**XK/XJ SERIES
VEHICLE CARE
HANDBOOK
SUPPLEMENT
JJM 10 16 18/001**

Engine Lubrication System

This information complements/replaces the existing information in Section 3 - Routine Checks, related to engine oil capacity and checking the oil level.

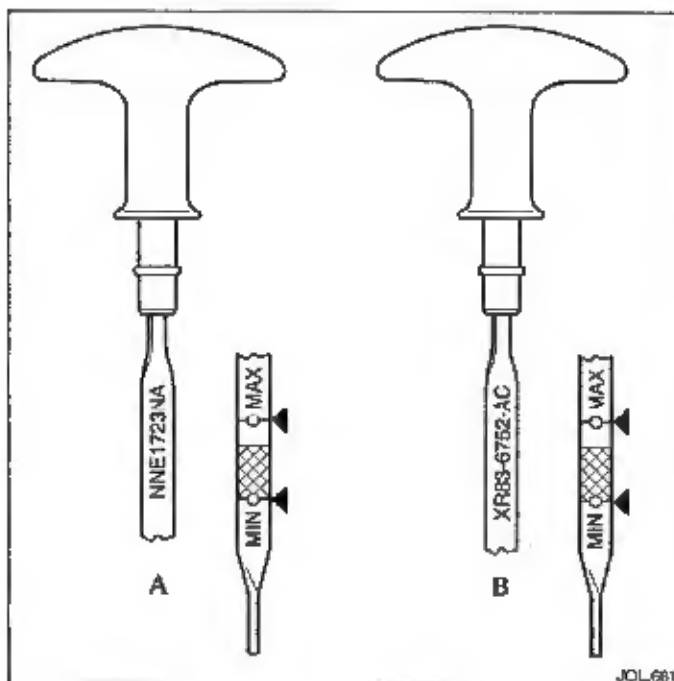
Modifications have been made to the engine lubricating system, part of which, is a new dipstick and an increase in oil capacity.

Both versions of the dipstick look similar, but may be identified by the part number stamped near the top. These are:

Pre-modification ('A' on illustration) - NNE1723NA.

Modified version ('B' on illustration) - XR83-6752-AC.

As a result of the modifications, the oil capacity for 3.2L, 4.0L, Normally Aspirated and Supercharged engines has increased nominally by:

1 Litre (1.75 Imp Pints) (1.06 US Quarts).
